EL07-039

ITB07-042

November 9, 2007

2008 G35, G37, QX56; INFINITI VOICE RECOGNITION SYSTEM UPDATE

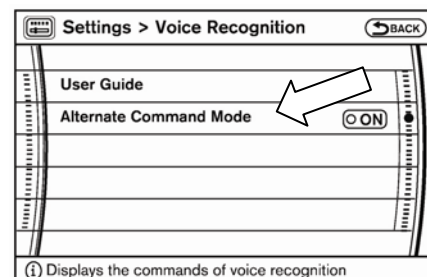
The Applied Vehicles listed above had a running change to the Infiniti Voice Recognition System.

The newer system has a simplified "Standard Mode" (which is the default mode) and an "Alternate Command Mode" for the more advanced user.

NOTE: Some vehicles built prior to the above VINs and Dates may have had the newer system installed at the Port. To confirm that the vehicle has the newer system, select the "Settings" Button, then on the screen select "Others > Voice Recognition" and see if the option for "Alternate Command Mode" is present.
